Addendum #3

Sanford Armory Renovation, 88 William Oscar Emery Drive, Sanford, Maine, Project Number 23SR15-424-D, BGS Project Number 2518, Bid Number 17-005.

FIGURE 3
 EXPOSED FOUNDATION DIMENSIONS
 GEOTECHNICAL ENGINEERING SERVICES
 ARMORY RENOVATIONS
 SANFORD, MAINE

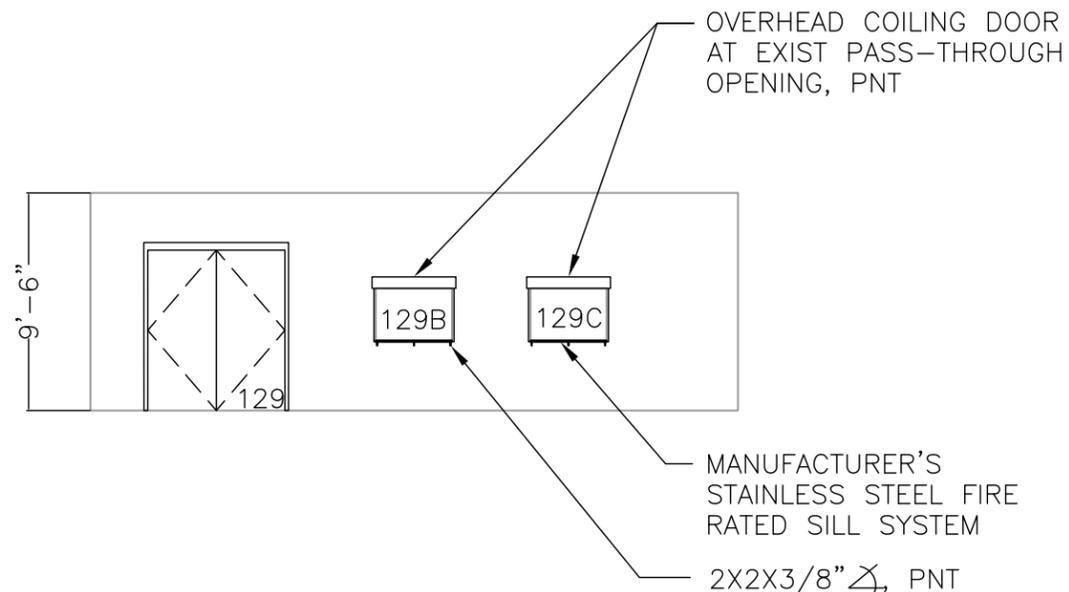
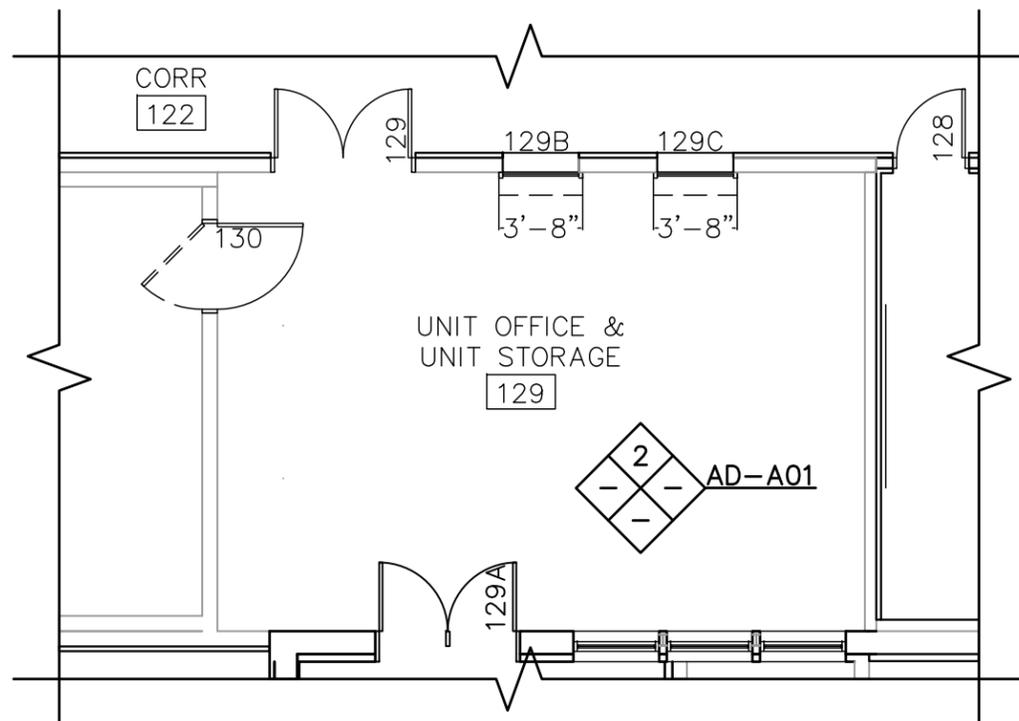
5. Question: Do you have the distance from top of grade to top of footing?

Answer: Please see the attached geotechnical report that indicates grade-to-footing distances at five test pit locations.
